**PLANT SPECIFIC SEISMIC ADEQUACY  
EVALUATION OF TURKEY POINT  
UNITS 3 AND 4 TO RESOLVE  
UNRESOLVED SAFETY ISSUE (USI) A-46  
AND GENERIC LETTER (GL) 87-02**

Final Report

April 30, 1993

Florida Power & Light  
P.O. Box 14000  
Juno Beach, FL 33408

## ITEM 6 INTAKE COOLING WATER PUMP - 3B

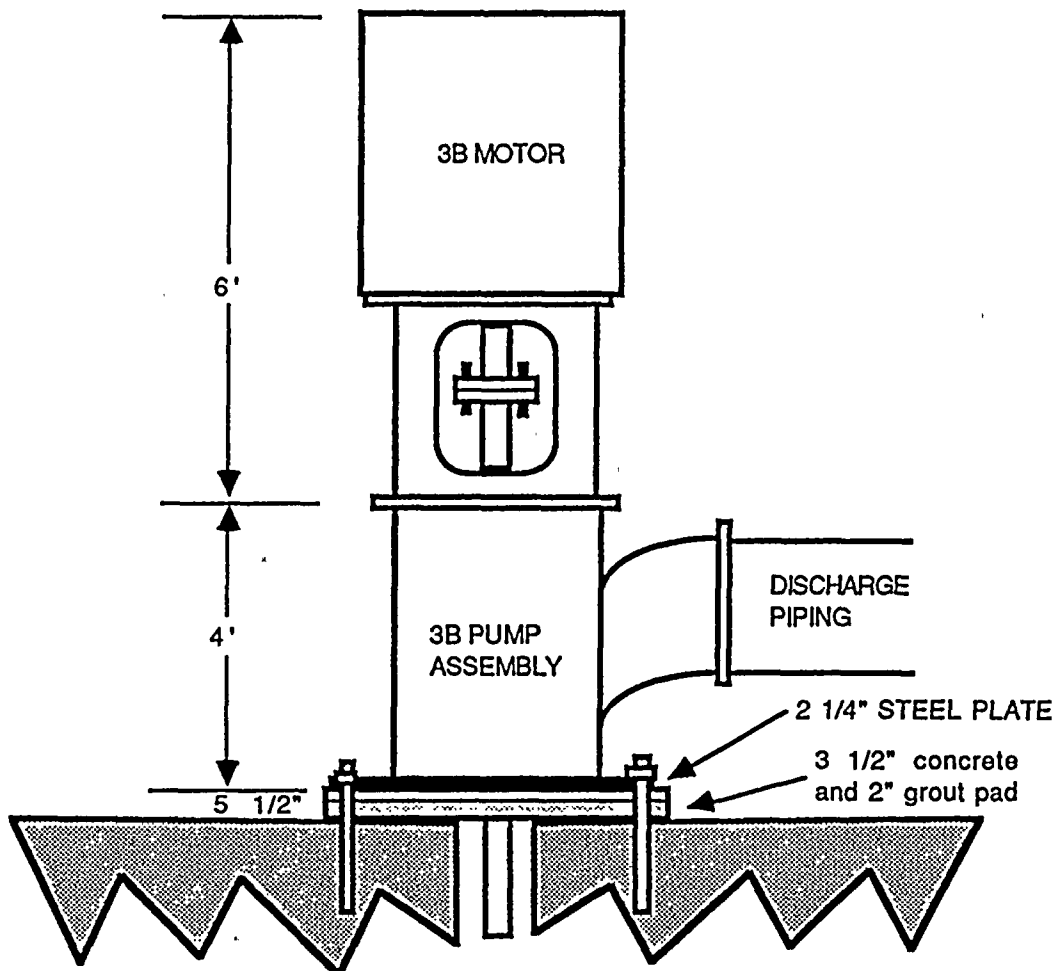
THE SRT WANTED TO REVIEW THE ANCHORAGE DRAWINGS & CHECK EMBEDMENT LENGTH.

CONCERNS: • CHECK PUMP SHAFT LENGTH & DETERMINE IF SHAFT HAS SUPPORTS OR BEARINGS - SHAFT LENGTH = 27'

ITEM 7 INTAKE COOLING WATER PUMP - 4B

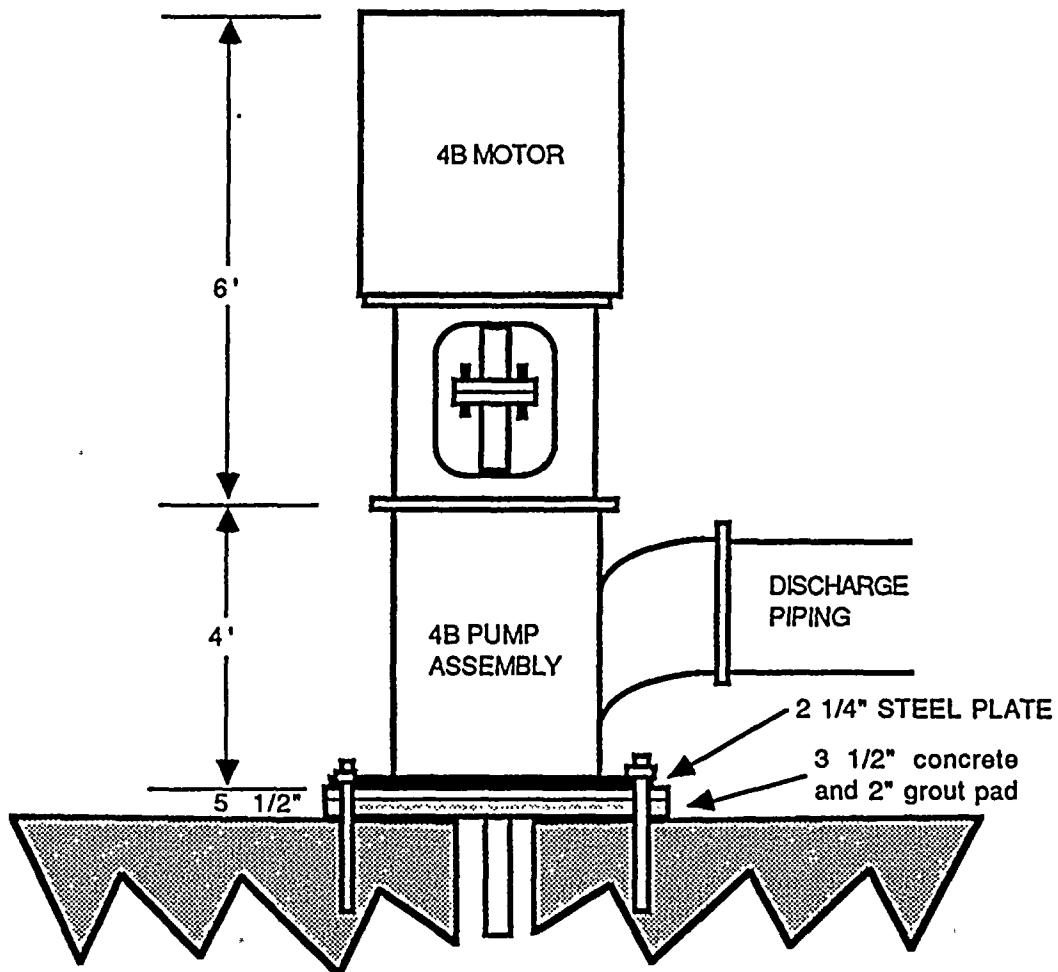
THE SRT WANTED TO REVIEW THE ANCHORAGE DRAWINGS & CHECK EMBEDMENT LENGTH.

## UNIT 3 CST TANK TANK MOUNTING WORKSHEET

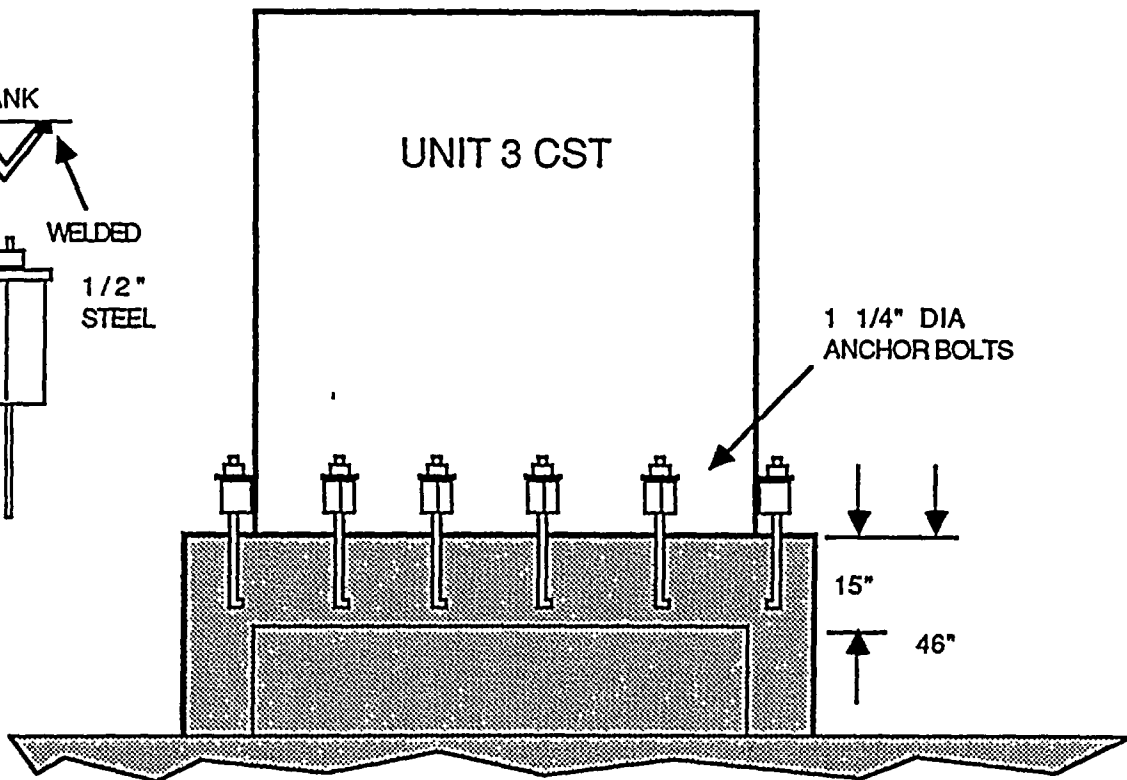
SEVERAL CHAIRS FOR THIS TANK HAVE BEEN BENT AND ARE NOT WELDED TO THE TANK

## UNIT 4 CST TANK TANK MOUNTING WORKSHEET

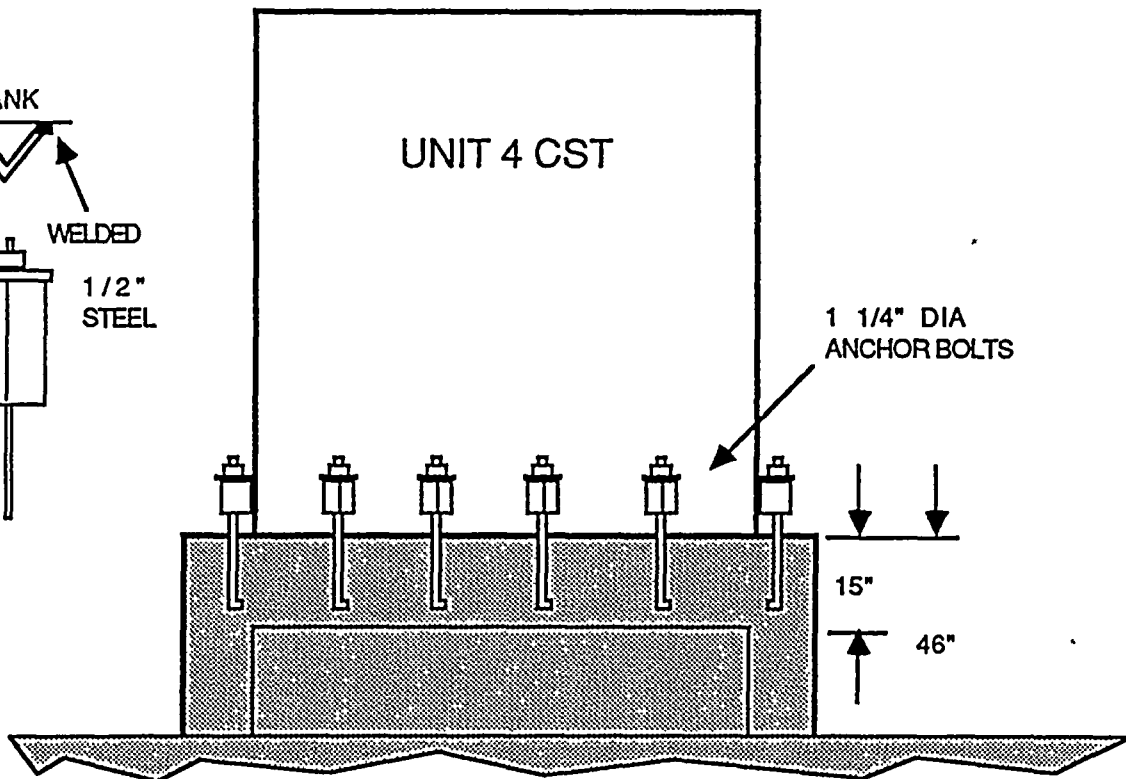
SEVERAL CHAIRS FOR THIS TANK HAVE BEEN BENT AND ARE NOT WELDED TO THE TANK

## B DAY TANK SEISMIC INTERACTION WORKSHEET

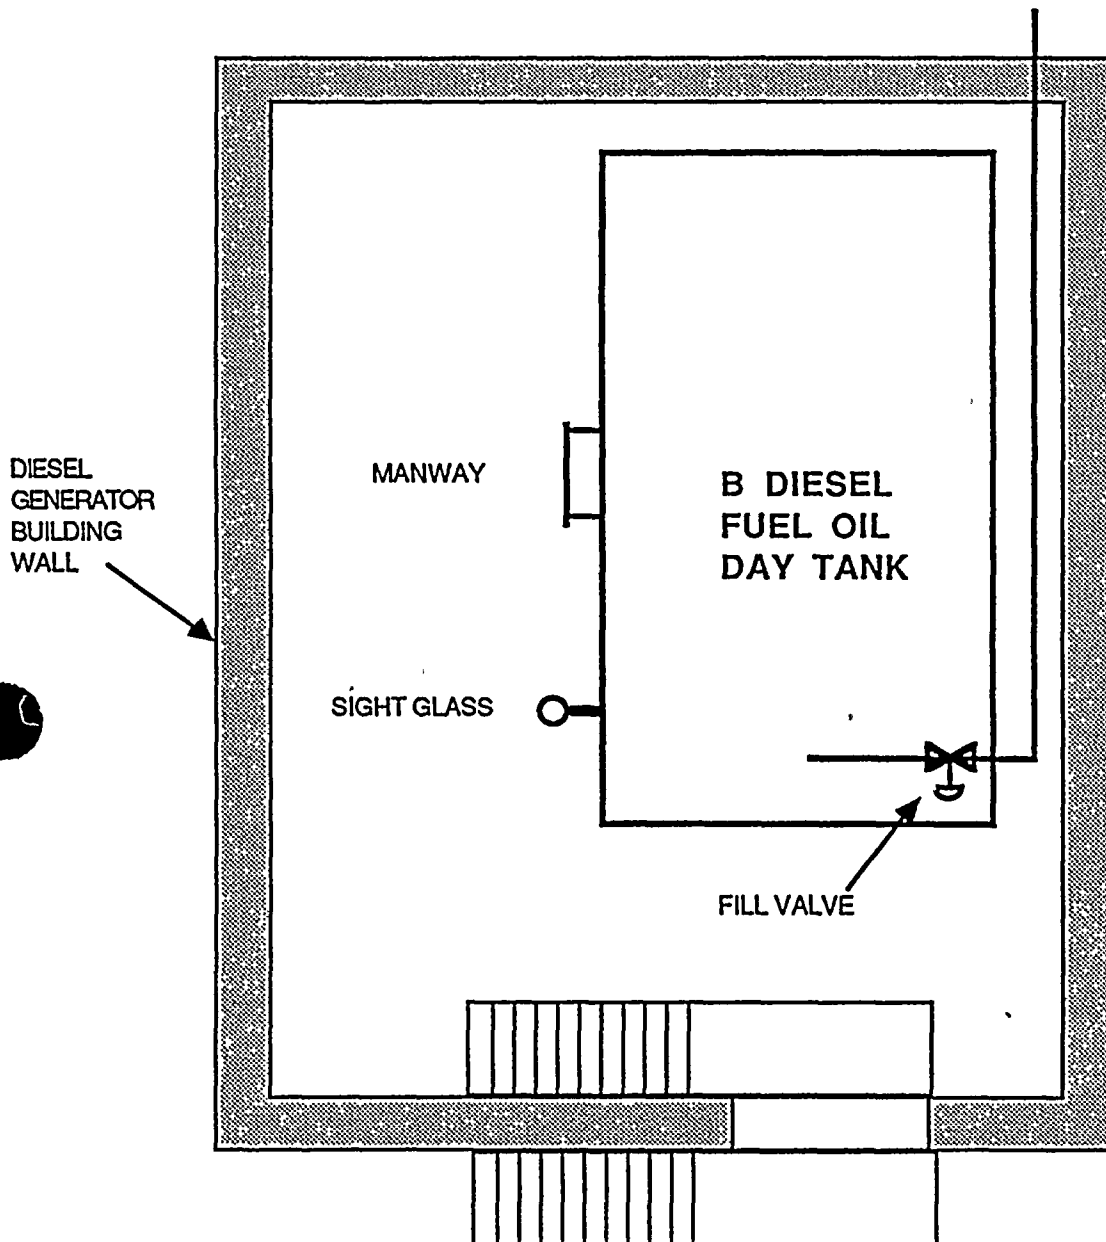
1. THE SRT REVIEWED THE TANK INSTALLATION IN ITS OWN ROOM. A REVIEW OF THE DRAWINGS SHOWING THE CURB DETAIL WITH REBAR CAGE & THE ANCHOR BOLTS INSIDE THE CAGE RESOLVED A CONCERN WITH BOLT EDGE DISTANCE.
2. AN INTERACTION CONCERN WITH THE GLASS SIGHT GLASS WAS IDENTIFIED.
3. THE SRT ALSO NOTED A POORLY DESIGNED HANGER FOR AN AIR-OPERATED FILL VALVE. FAILURE OF THIS HANGER OR VALVE WOULD NOT CREATE A CONCERN WITH THE DAY TANK.

ITEM 20      EDG    AIR START TANKS    - B

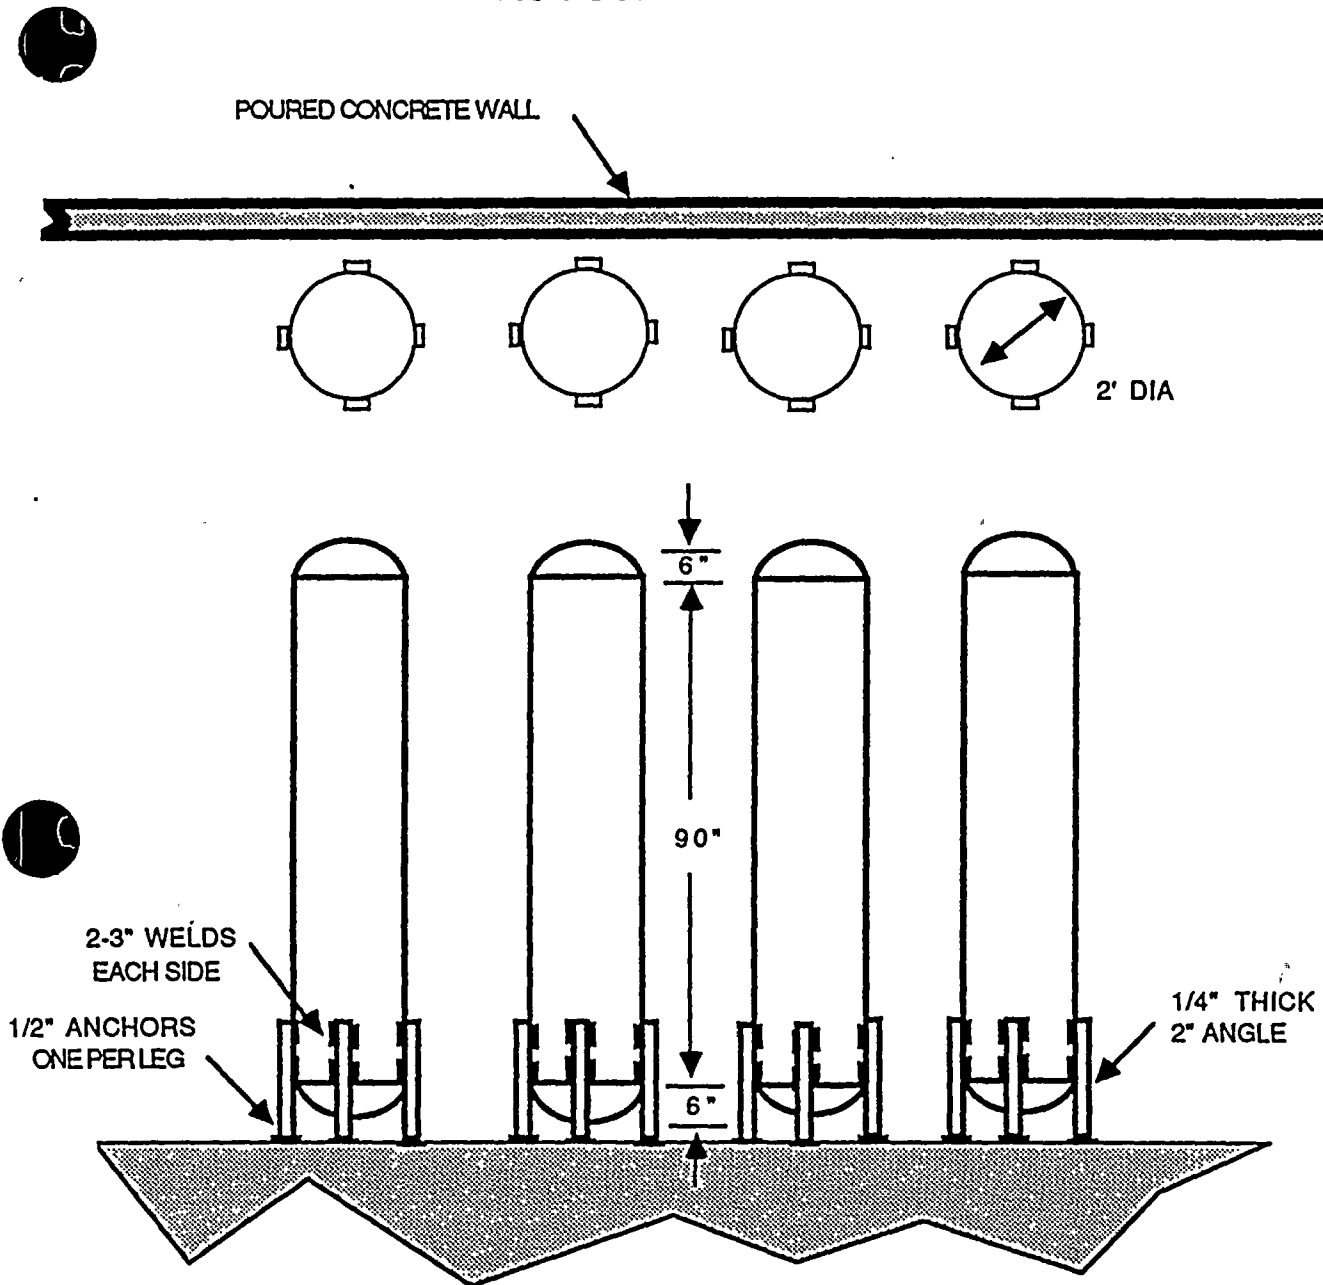
SRT REVIEWED THE ANCHOR BOLT DRAWINGS AND CALCULATION. DID NOT HAVE ANY ANCHORAGE CONCERNS.

ITEM 22 EDG LOCAL CONTROL Panel B

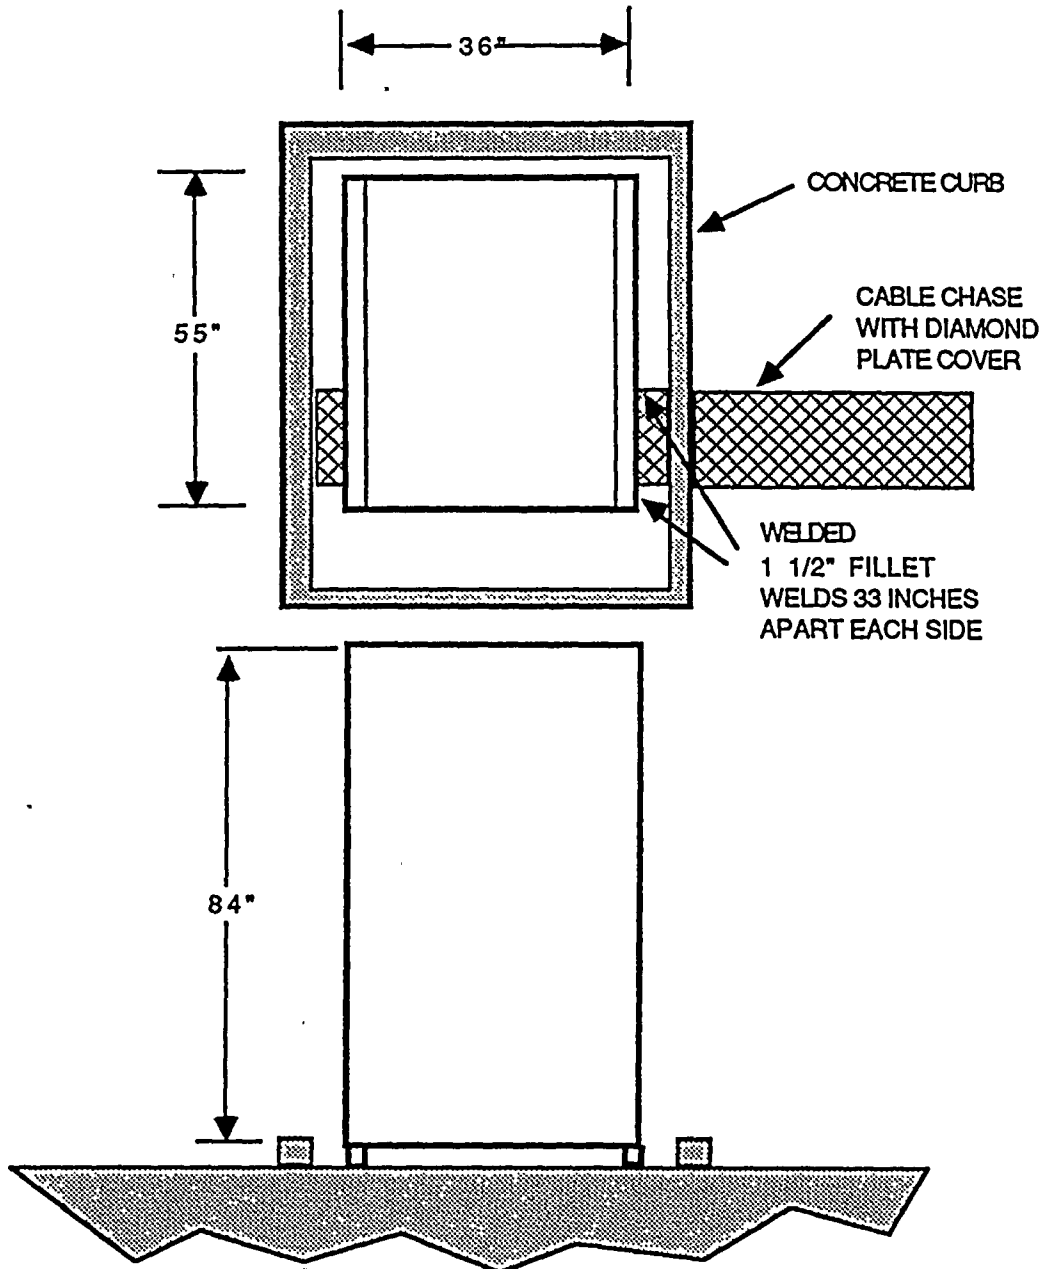
SRT REQUESTED A CALCULATION  
EVALUATING THE WELD CAPACITY.

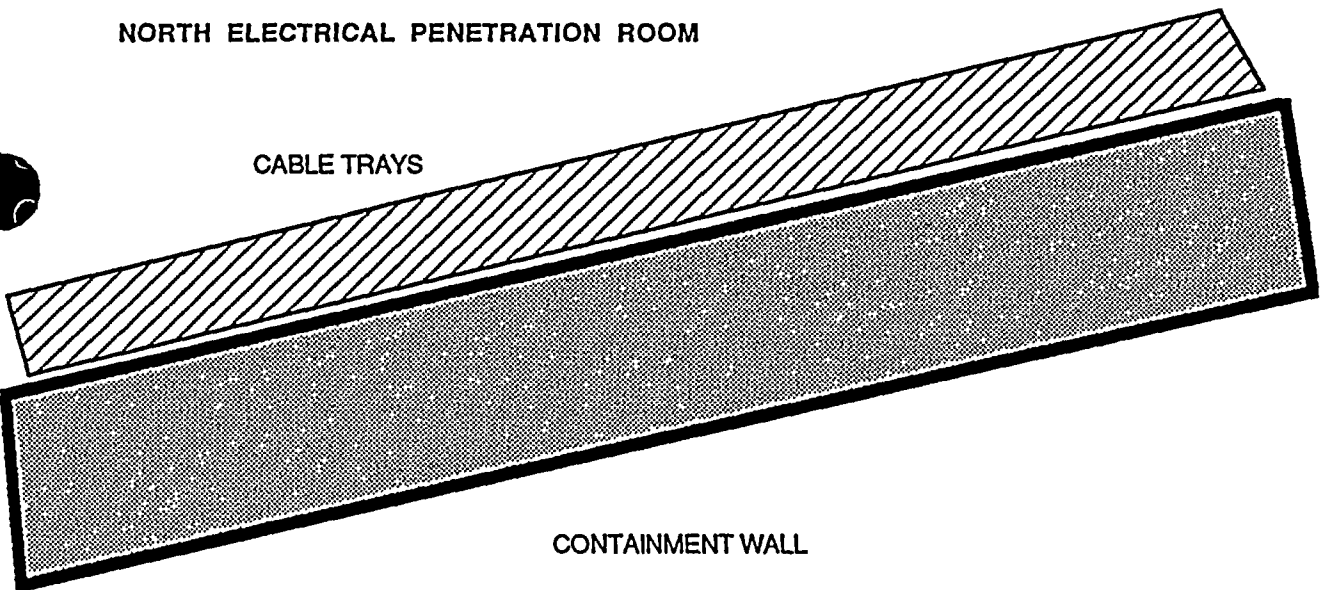
THE SRT DID NOT NOTE ANY SEISMIC INTERACTIONS CONCERNS FOR THIS ROOM

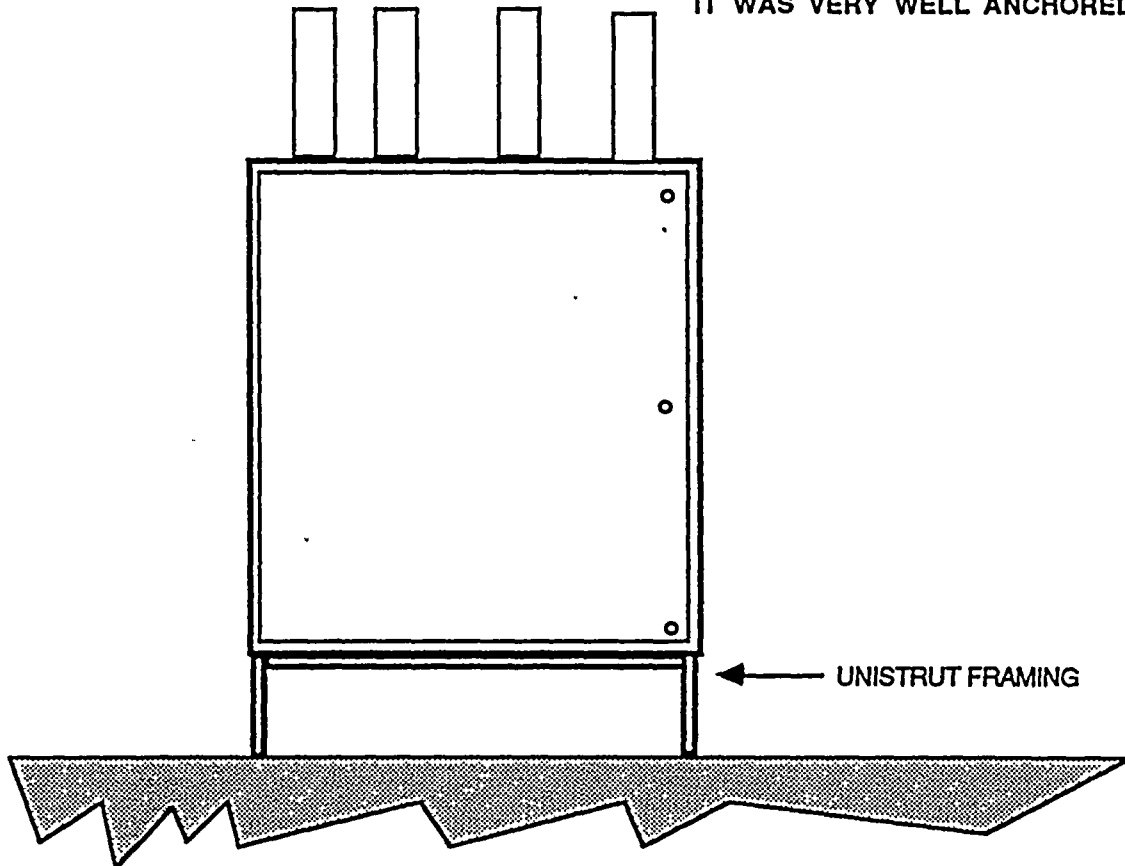
THE SRT APPLIED FORCES TO THIS  
CABINET AND DETERMINED THAT  
IT WAS VERY WELL ANCHORED
